### STAFF RECOMMENDATION

1414 Calvin Avenue

November 19, 2018

**Description of Project:** Application is to construct a rear addition that is wider than the historic house.

**Figure 2:** Rear elevation where selective demolition will occur

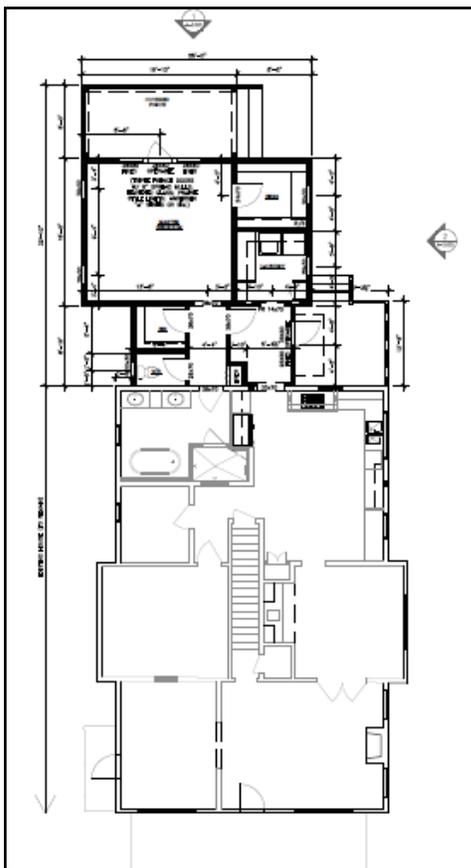
Demolition: Selective demolition will occur on the rear elevation where portions of the rear wall will be removed to accommodate the addition. This work will not damage any significant historic features and will not be visible from the street. Staff finds that the proposed selective demolition work meets Section III.B.2 for appropriate demolition and does not meet Section III.B.1 for inappropriate demolition.

**Figure 3: Note that addition is wider than house**

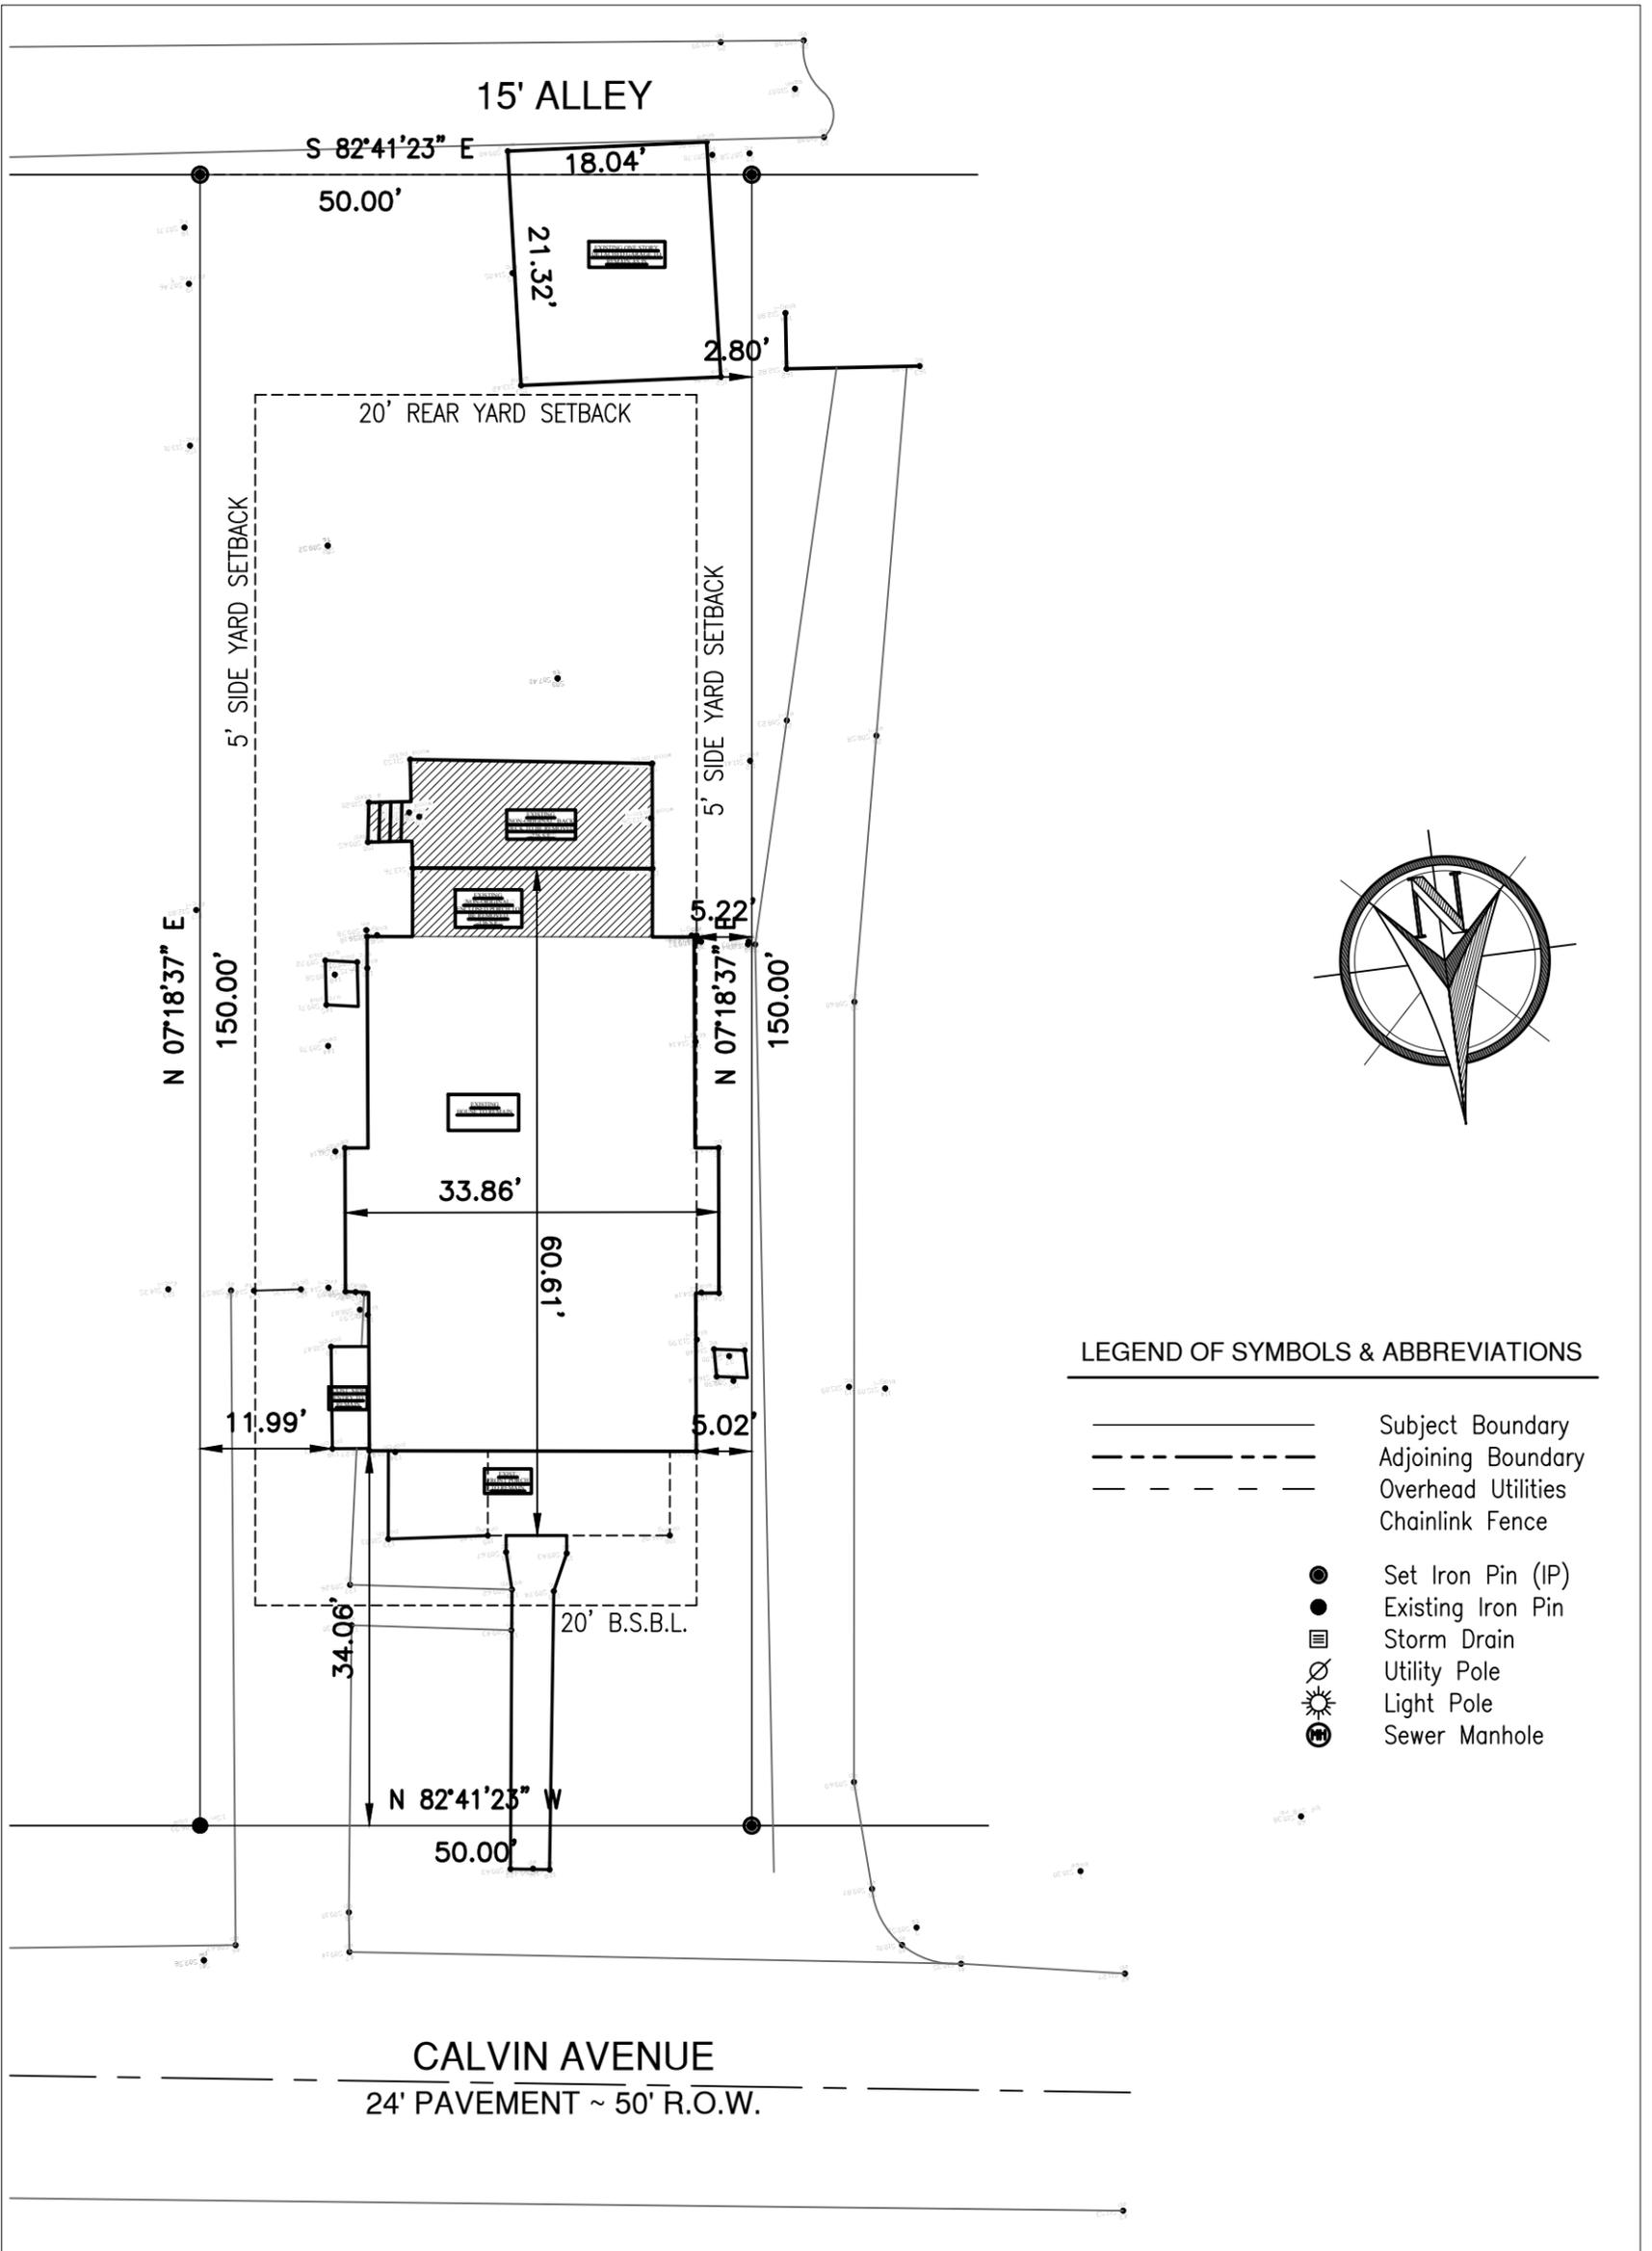
Location & Removability: The addition is sited at the back of the house, as per the guidelines. The addition has a minimal connection to the back of the house. It does not impact the rear corners of the house or the rear dormer, and could be removed in the future without damage to the integrity of the historic house. The addition has a one foot, six inch (1'6") inset on the east side. On the west side, a new open porch will be

constructed flush with the existing side wall, and the covered portion of the addition will be inset ten feet (10'). These insets are appropriate for a single story addition to a single story house. However, on the east side, the addition steps out again a full five feet (5'), such that it extends past the main wall of the house. The Commission has allowed additions to step back out after an inset, but generally only if they were not wider than the historic house. In this instance, there is a two foot wide bay along the side of the house; staff finds that increasing the width of the addition to match this width could be appropriate, as this is only a one story addition and it is set back more than sixty feet (60') from the front of the house. Extending wider than the existing house is only appropriate where the site is somehow limited or the lot is particularly wide, which is not the case in this instance. There appears to be room to move the addition without changing the footprint design and the applicant has not provided a reason, to date, that may not be readily visible as to why the addition cannot be moved over. Staff will continue trying to reach the applicant to understand the reason for this design. Staff

recommends that the footprint of the addition be reduced or shifted over such that it extends no wider than the full width of the historic house. With this revision, staff finds that the addition's location and removability meet Sections II.B.10.a and II.B.10.d. of the design guidelines.

**SITE PLAN**

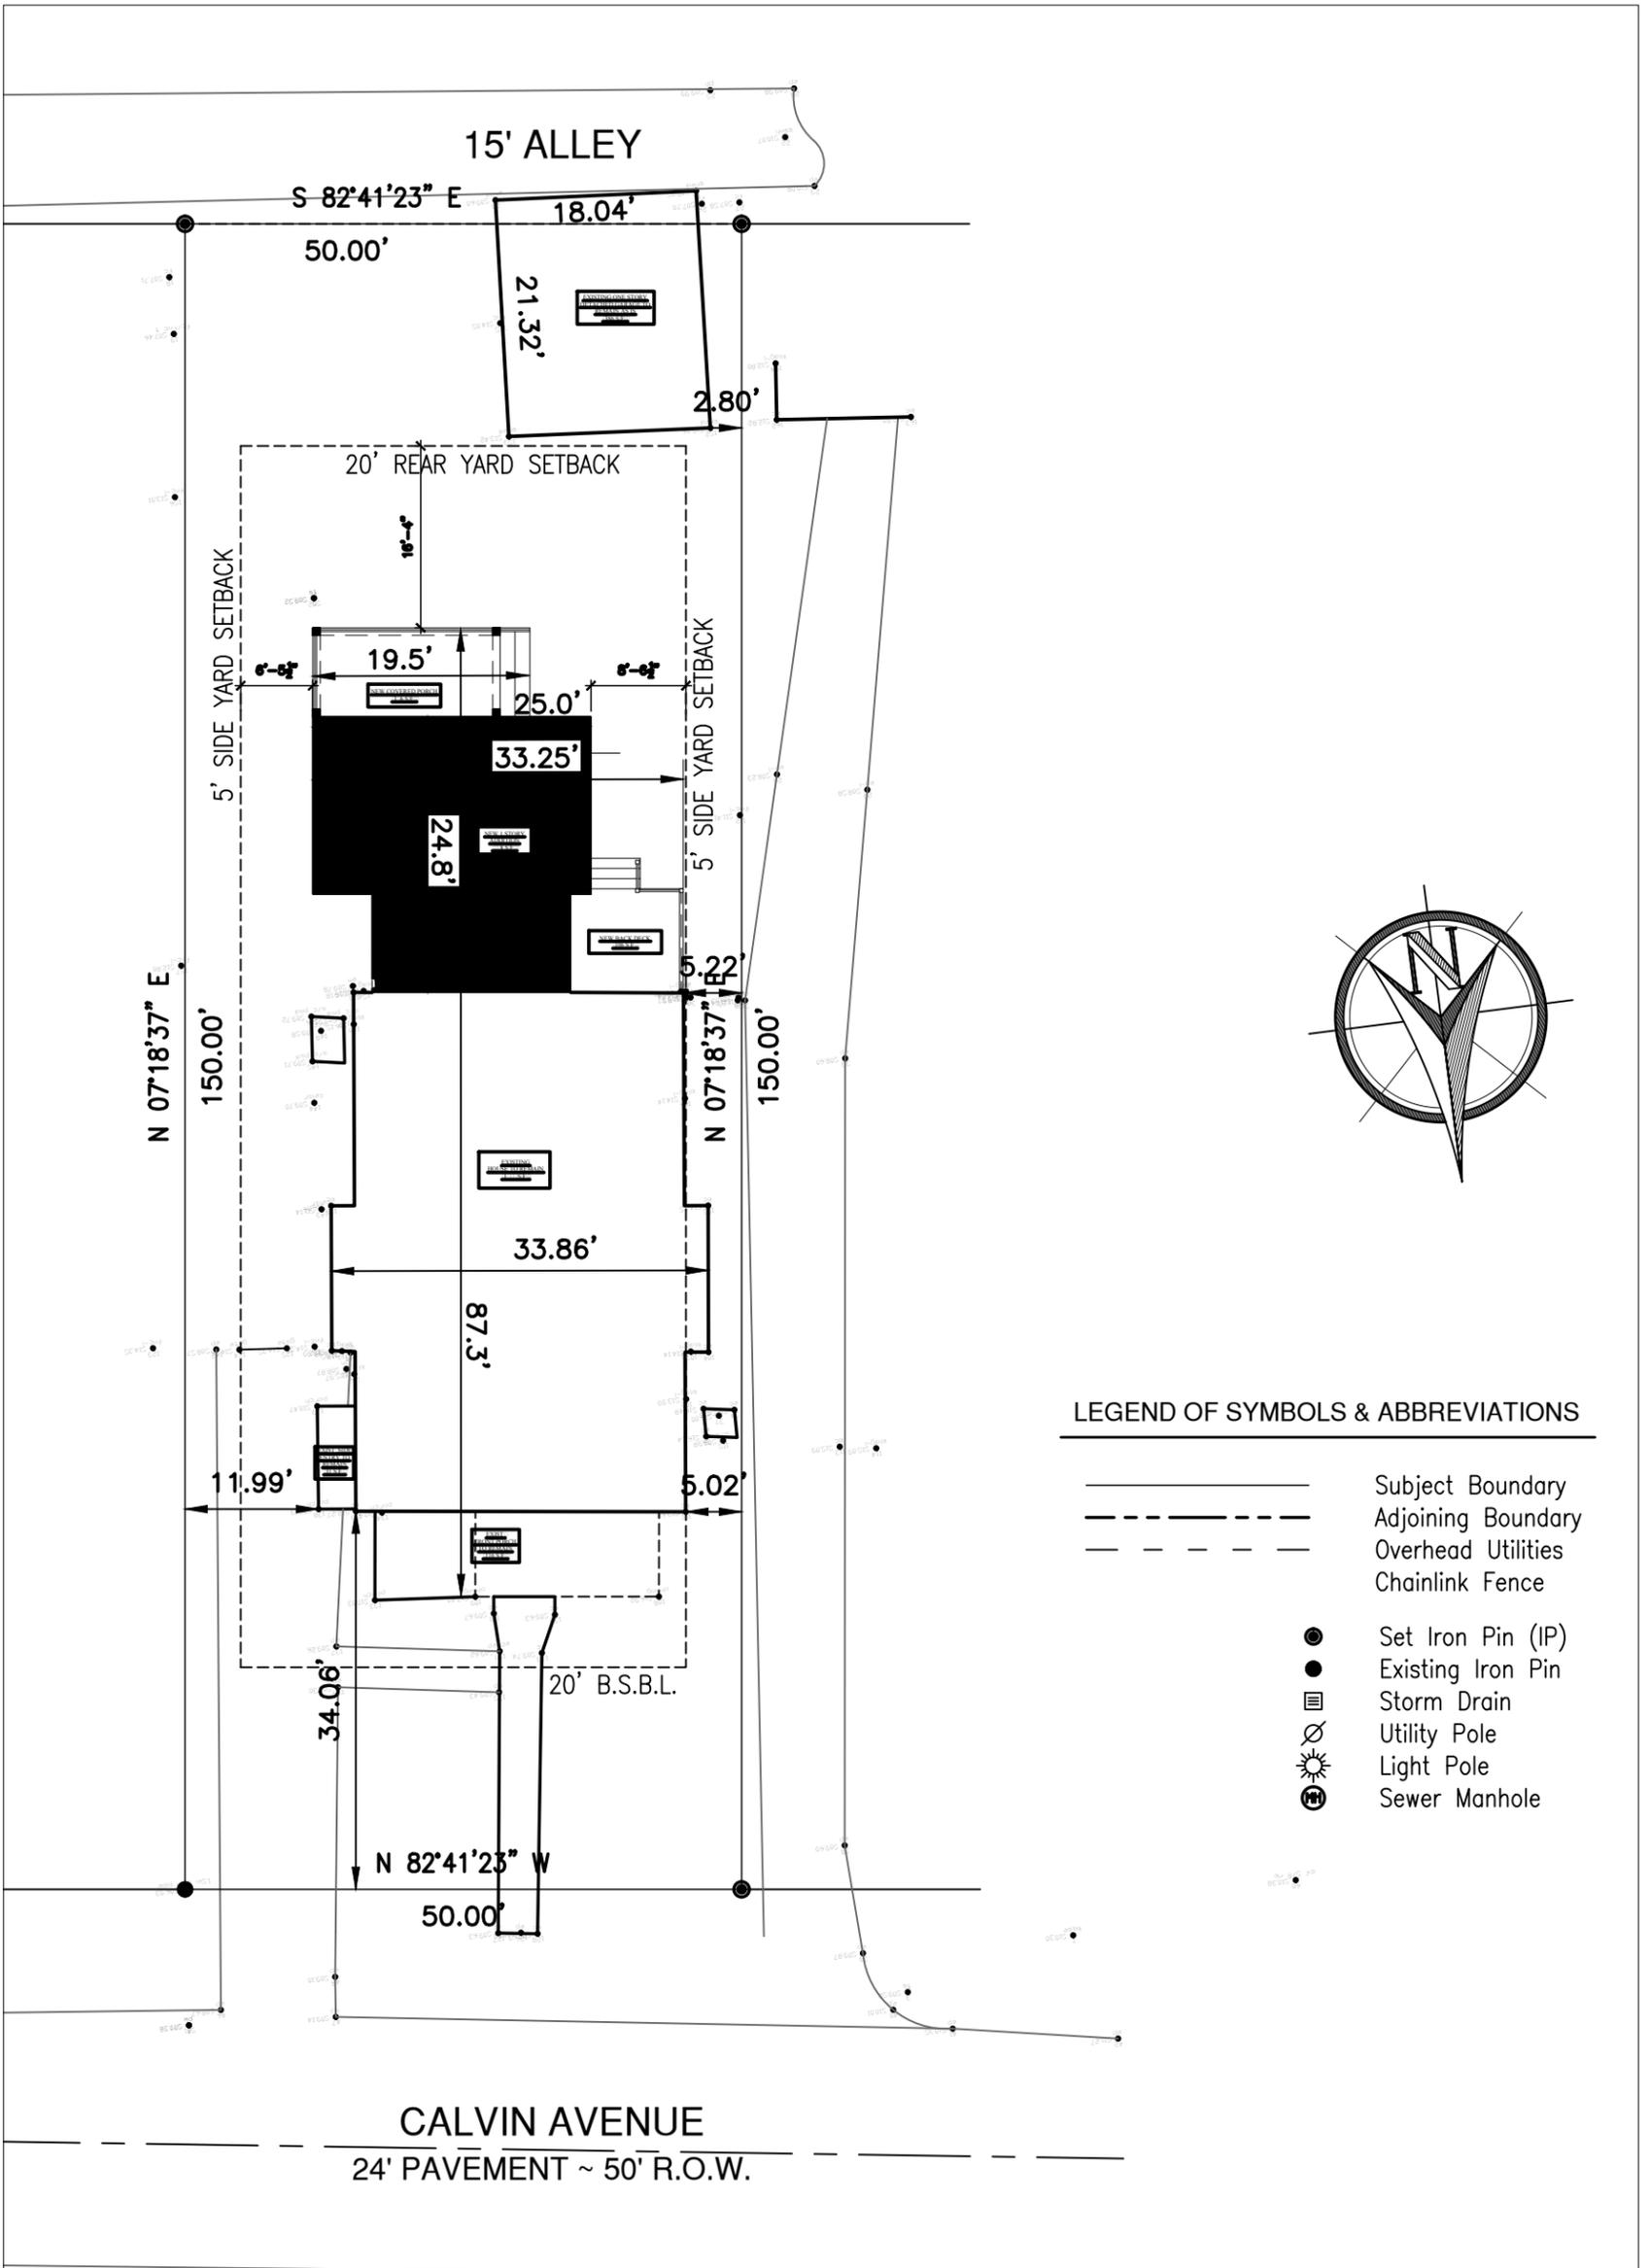
**Analysis and Findings:** The application is for the construction of a rear addition, which is shorter and narrower than the house. However, the addition is sited off to one side, such that it extends one foot wider than the footprint of the historic house on the eastern side.

1. The footprint of the addition shall be reduced or shifted so that it extends no wider than the projecting side bay of the historic house; and
2. Staff shall approve the doors, windows and porch column wrap prior to purchase and installation; and
3. The HVAC shall be located behind the house or on either side, beyond the mid-point of the house
